APPLICATION NO.	FILING DATE	FIRST NAMED INVENTOR	ATTORNEY DOCKET NO.	CONFIRMATION NO.
10/516,659	12/01/2004	Hermann Baumann	P/4674-2	8761
Klaus P. Stoffe	7590 ·	EXAMINER		
Wolff & Samso	on PC	TRIEU, THAI BA		
One Boland Drive West Orange, NJ 07052			ART UNIT	PAPER NUMBER
West Glangs, No 07032			3748	
			MAIL DATE	DELIVERY MODE
			06/22/2007	PAPER

## **DETAILED ACTION**

This Office Action is in response to the Amendment filed on April 26, 2007.

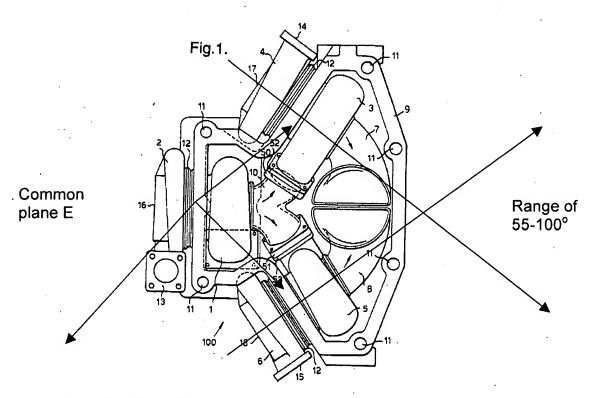
Ramsden discloses an internal combustion engine with a first, a second and a third exhaust gas turbocharger (3, 4; 5, 6; 1, 2) for charging the internal combustion engine, each of the exhaust gas turbochargers comprises a compressor wheel and a turbine wheel, which rotate around a common charger axis (Not Numbered), a first exhaust gas feed line arranged to lead to the first exhaust gas turbocharger, a second exhaust gas feed line arranged to lead to the second exhaust gas turbocharger, the three exhaust gas turbochargers (3, 4; 5, 6, 1, 2) having parallel air flows (See Figures 4-5), a carrier housing (9) arranged to hold the two exhaust gas turbochargers, a manifold arranged to collect exhaust gas streams downstream of the first and second exhaust gas turbochargers (3, 4; 5, 6), and a common exhaust gas discharge line (10) connected to the turbochargers (3, 4, 5, 6), the three exhaust gas turbochargers (3, 4, 5, 6; 1. 2) being arranged to lie in a common plane (E), the two charger axes of the first exhaust gas turbocharger and the second exhaust gas turbocharger are positioned at an angle to each other in an angular range of 55-100° and the charger axis of the third exhaust gas turbocharger lies within the angular range, the third exhaust gas turbocharger (1, 2) being arranged centrally between the first exhaust gas turbocharger

wherein the plane is parallel to a top of the internal combustion engine (See Figure 4);

and the second exhaust gas turbocharger (See Figures 1, 3, and 4-5);

wherein the exhaust gas discharge line is arranged to lie in the plane (See Figure 4);

wherein the engine includes a cylinder heads and further comprises air feed lines (24a, 24b) located above the cylinder heads for supplying uncompressed air to the first and second exhaust gas turbochargers (3, 4; 5, 6); a filter (not shown) installed in an upstream direction of the air feed lines (24a, 24b) on an opposite side from the force; and

wherein the exhaust gas of the third exhaust gas turbocharger is guided into the manifold (from 1 to 3 and 5, then to 7 and 8) (See Figure 1).

Additionally, Ramsden does discloses a third exhaust gas turbocharger arranged centrally between the first and second turbochargers (See the attached Figure 1 above).
